CERTIFICATE OF APPROPRIATENESS

Property: 2017 Preston St, Lots 1, 2, 3, & 12, Tract 13, Block 186, SSBB Subdivision. The property includes a historic 55,581 square foot five-story commercial building situated on a 21,750 square foot (152' x 160') corner lot.

Proposal: Alteration – Windows/Doors/Stairs

HAHC Action: Approved

NORTH ELEVATION FACING CHARTRES STREET

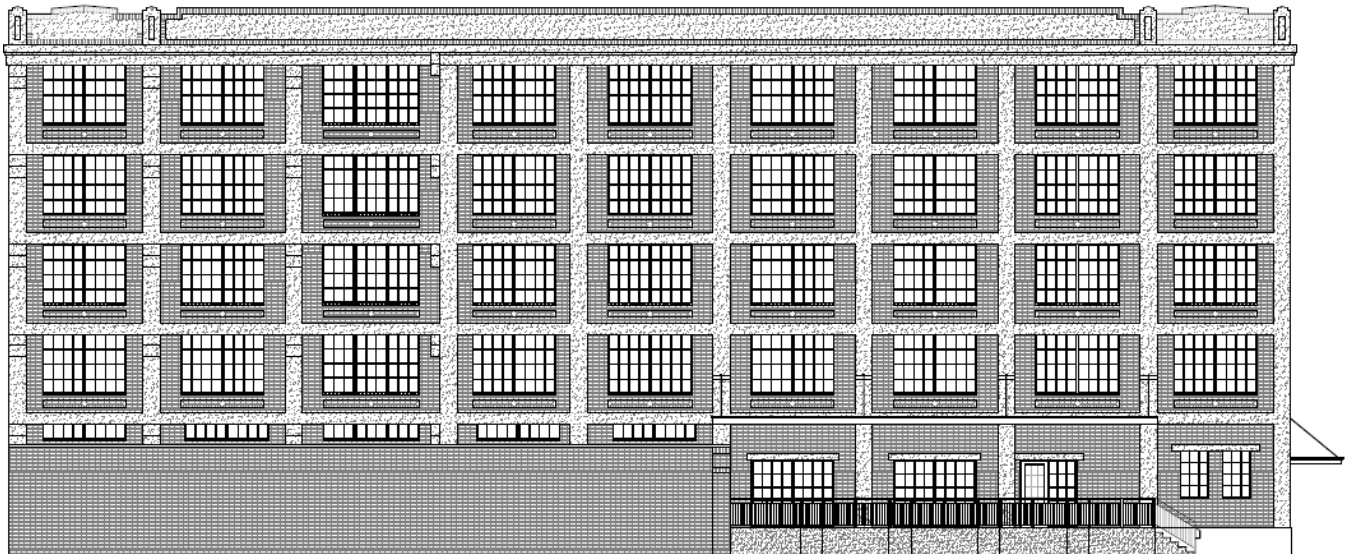
- Remove three overhead garage doors and install new steel windows within the openings to match existing windows.
• Construct new concrete stairs with a 42" guard rail on the existing loading dock.

North Elevation: The applicant proposes to remove three overhead garage doors and install new doors and windows within the existing openings. The windows will match existing light patterns.

North Elevation: The applicant proposes to construct new concrete stairs with a new 42" guard rail on the existing loading dock.

SOUTH ELEVATION FACING ST. EMANUEL

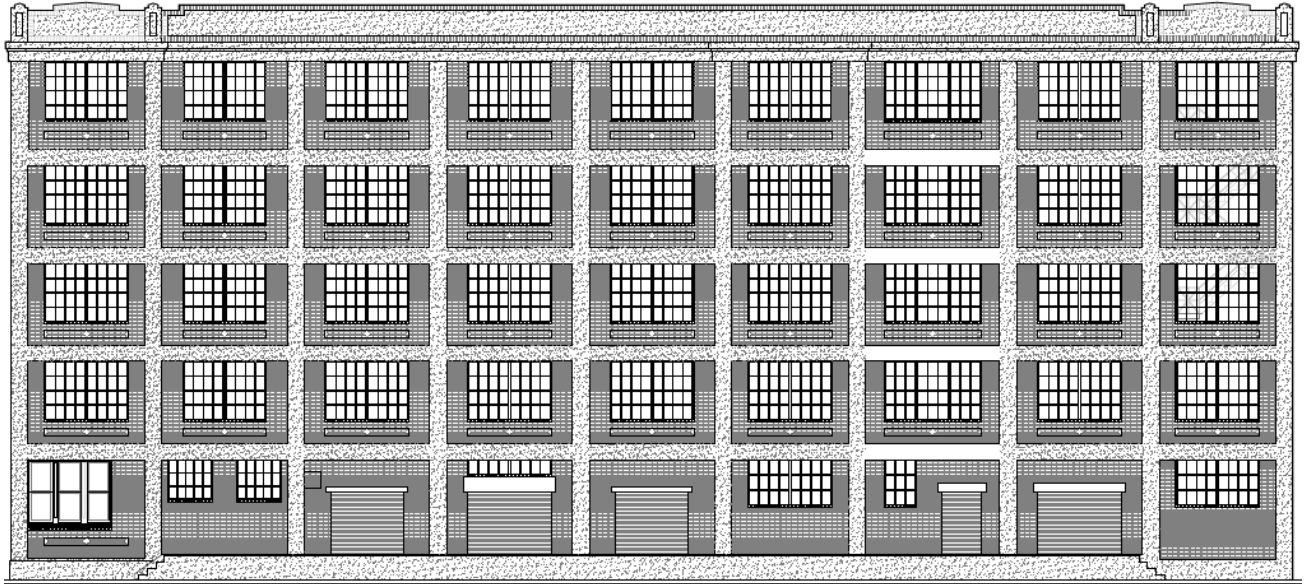
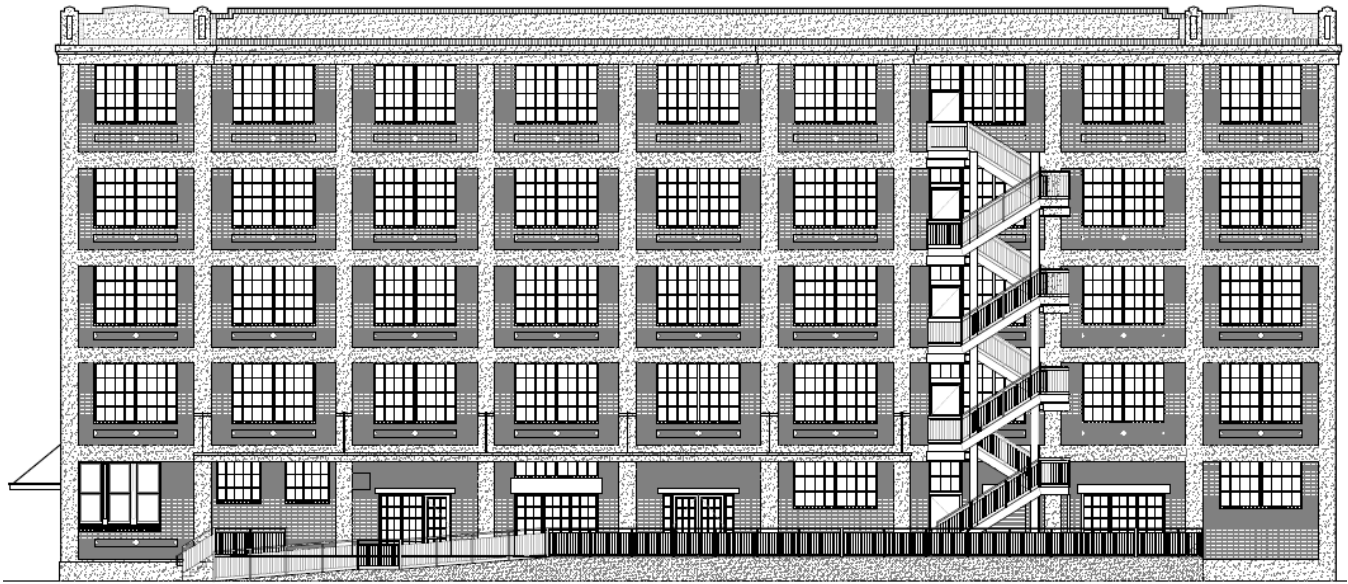
- Construct a new ADA-compliant ramp within the existing concrete platform with 42" guardrail around the platform's perimeter.
• Construct a new fire stair in the seventh bay, which will be self-supporting and will not touch the historic building except at access doors. Stair platforms will be spaced approximately 12' apart.
• Install four new fire-rate doors within the existing openings to allow for egress to the new fire stair.
• Remove five overhead garage doors and install new steel windows within the openings to match existing windows.

Windows/Doors: South Elevation: The applicant proposes to install four new fire-rated doors within the existing openings to allow for egress to the new fire stair. The applicant also proposes to remove five overhead garage doors and install new doors and windows within the existing openings. The windows will match existing light patterns.

Exterior Materials: South Elevation: The applicant proposes to construct a new ADA-compliant ramp within the existing concrete platform. A new 42" guard rail will be constructed on the platform's perimeter. Additionally, a new five-story exterior fire stair will terminate on the same platform. The fire stair will be located in the seventh bay, replacing the existing exterior stair currently located in the ninth bay, which no longer meets code requirements. The new stair will be self-supporting, and will not touch the historic building except at the access doors. See "Detail – New Exterior Stair" for more detail.
